Re: 798 塞尔维亚文化处项目图纸及设计要求的疑问

Questions on drawing and design of "the Cultural Center of the Republic of Serbia in Beijing" tender documents

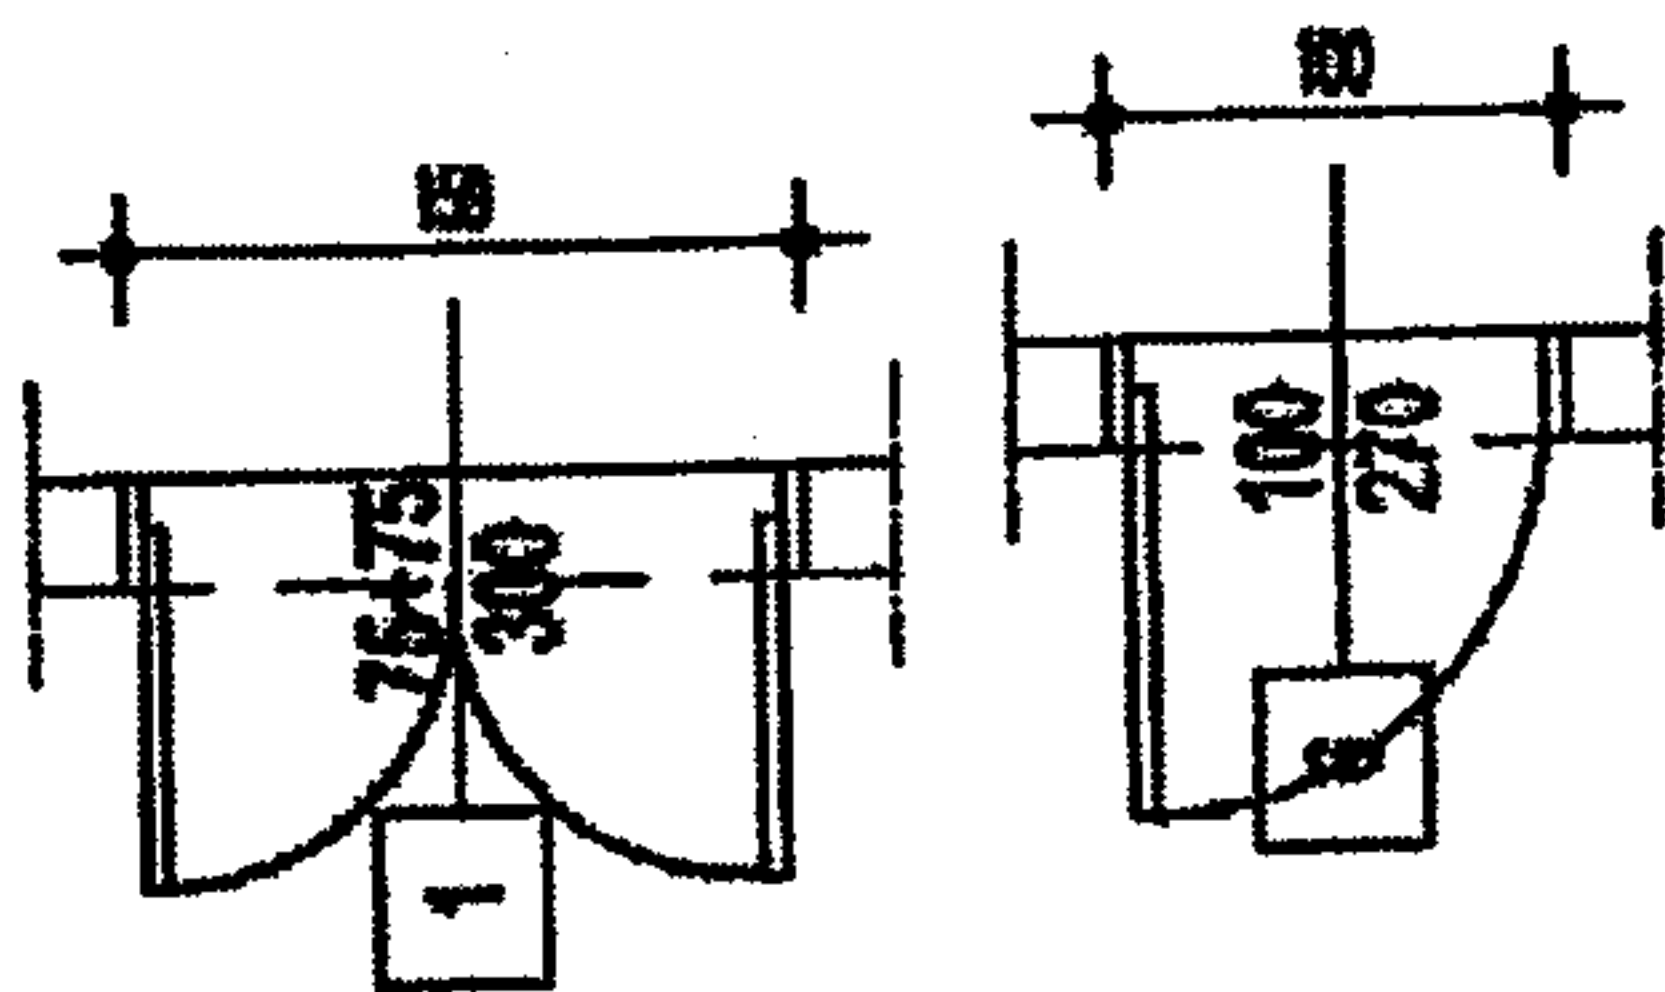
8. 窗编号 4，图纸右侧一层新开窗，现场没有窗，按物业要求不可动外立面，是否确认

Regarding to the window no.4 in drawing, it is a new window in 1<sup>st</sup> floor, but this window on site doesn' t exist, according to regulation of building management, it can' t be changed for façade.
